GOVERNMENT OF THE DISTRICT OF COLUMBIA
DEPARTMENT OF TRANSPORTATION

MEMORANDUM

SUBJECT: **Second Supplemental Report for BZA Case No. 19169 - 317 K Street NW**

Figure 2 Parking Inventory Map (Source: Grove/Slade)

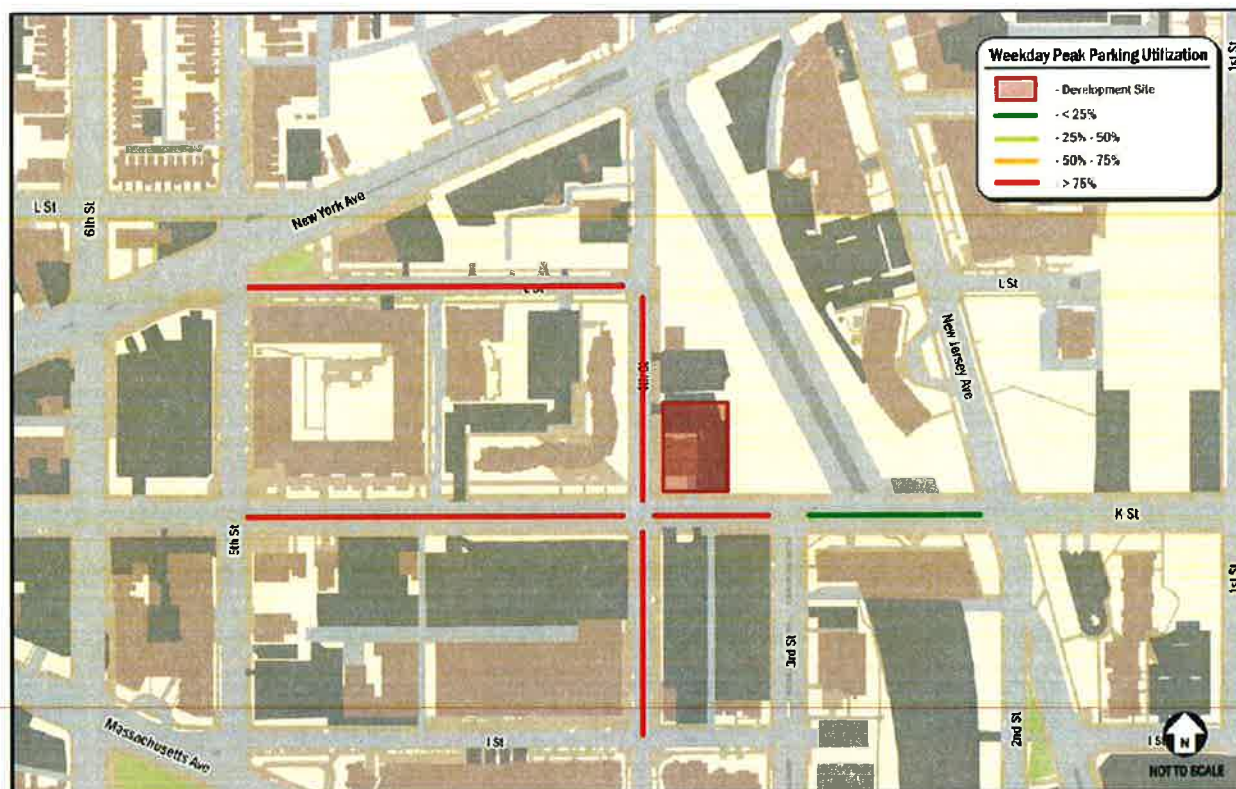
The inventory noted a total of 146 curbside parking spaces in the vicinity; 18 non-metered, 22 RPP, and 106 metered spaces. The spaces located adjacent to the subject site on 4th Street and K Street are metered. The parking inventory is illustrated in Figure 2.

Within the observation period, the peak parking utilization occurred at 8:00pm when 91% of all spaces in the vicinity were occupied. Of note, the 18 non-metered spaces identified in the analysis are located

on the K Street bridge over I-395 where parking is prohibited. Therefore, the parking inventory revealed 100% utilization of legal parking spaces in the study area.

Figure 4 Site Plan (Source: PGN Architects)

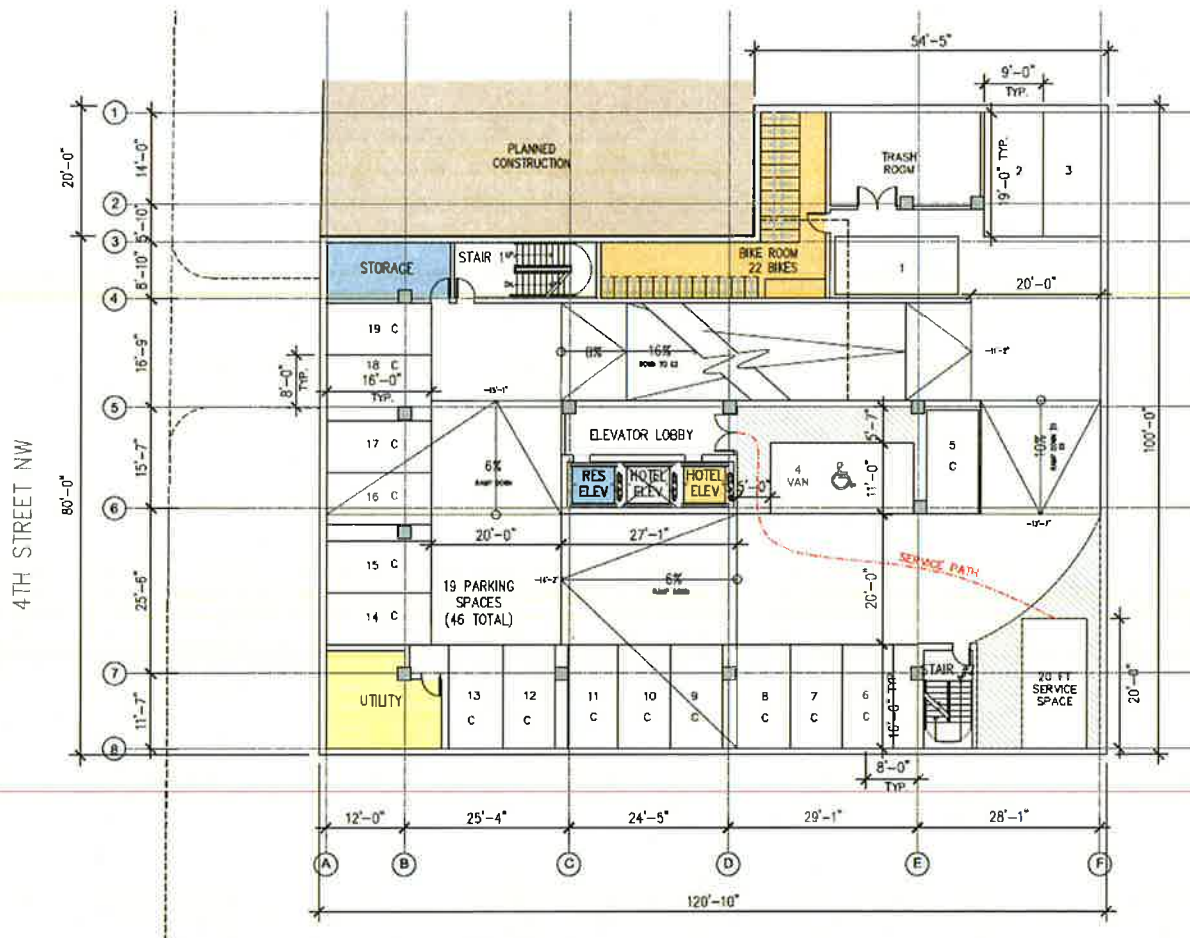
DDOT's Design and Engineering Manual prohibits truck backing maneuvers through public space. The Applicant coordinated with DDOT on several site design schemes with different attempts to accommodate the loading facilities in a manner consistent with DDOT standards. Ultimately, due to the relative small size of the lot and the desire to avoid creating a curb cut on K Street, DDOT determined that a 30-foot loading berth could not be accommodated on-site without backing maneuvers. The Applicant proposes to accommodate loading via a combined curbside loading zone on 4th Street that may also be used for valet operations as shown in Figure 4. A service corridor would connect the

proposed curbside loading area to the buildings back of house area. Earlier versions of the site plan did not include this corridor, but the Applicant revised the site plan to include this facility.

The Applicant and DDOT coordinated closely to create a functional 20-foot service/delivery space. The space is located on the same level as and is in relatively close proximity to the core. Such a design results in a loading space that is likely to be utilized for deliveries and will accommodate some on-site loading activity while lessening the demand placed on curbside loading.

The Applicant must submit a formal loading zone request to DDOT and will also need a public space permit to occupy the curbside for a valet staging zone. DDOT's lack of objection to the loading variance request does not constitute approval for the curbside loading zone or valet staging zone. DDOT will evaluate the requests through the aforementioned processes to determine their validity. The Applicant must continue to coordinate with DDOT to determine appropriate design and operations of the potential combined commercial loading and valet staging proposal. Any proposal would need to be designed and operated in a way such that impacts to the existing curbside are minimized through time-of-day restrictions and combined uses that would use less space overall compared to an individual commercial loading zone adjacent to a separate valet staging zone.

The preliminary public space plans do not match the existing public space adjacent to the site. As noted in the Loading section, the proposed loading and valet curbside uses may conflict with the existing streetscape on 4th Street, which was recently installed as part of a DDOT streetscape project for the K Street NW corridor. The public space adjacent to the proposed curbside loading uses feature established trees in large tree boxes, leaving limited space for a step out zone for valet customers and staging area for loading activities. Additionally, there is street furniture in between the tree boxes, including a multi-space meter. If approved for the desired curbside uses, the Applicant will need to coordinate with DDOT on an appropriate streetscape that preserves established trees while meeting the curbside use needs. If necessary, the Applicant will be responsible for relocating the multi-space meter.

- Instruct any delivery using a truck 20 feet in length or shorter to use the on-site service delivery space.
